UNITED STATES PATENT AND TRADEMARK OFFICE

**Advisory Action
Before the Filing of an Appeal Brief**

10/754,394

WALSH, MICHAEL FRANK

Figure 1

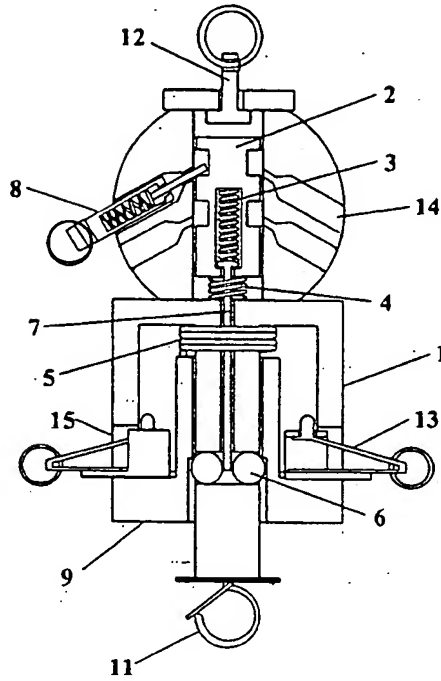
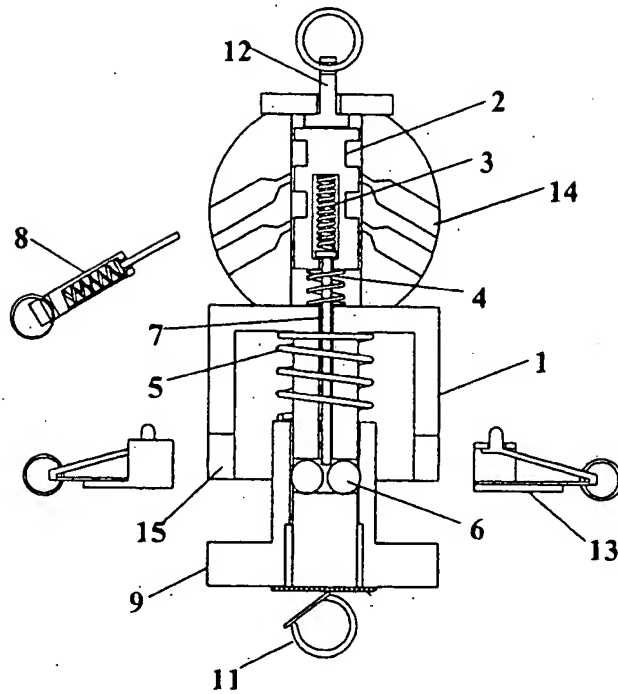
Continuation of 13. Other: Figure 1 needs to be broken into two figures such that the result renders Figure 1A and Figure 1B.

not accepted
E.L.
5/18/05

Figure 5

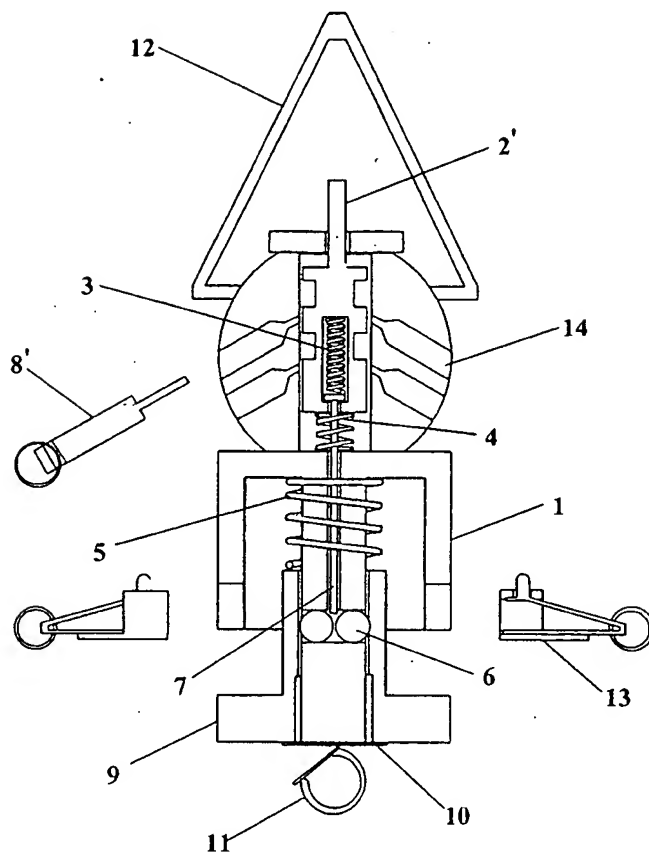
Accepted
F.L.
5/18/05
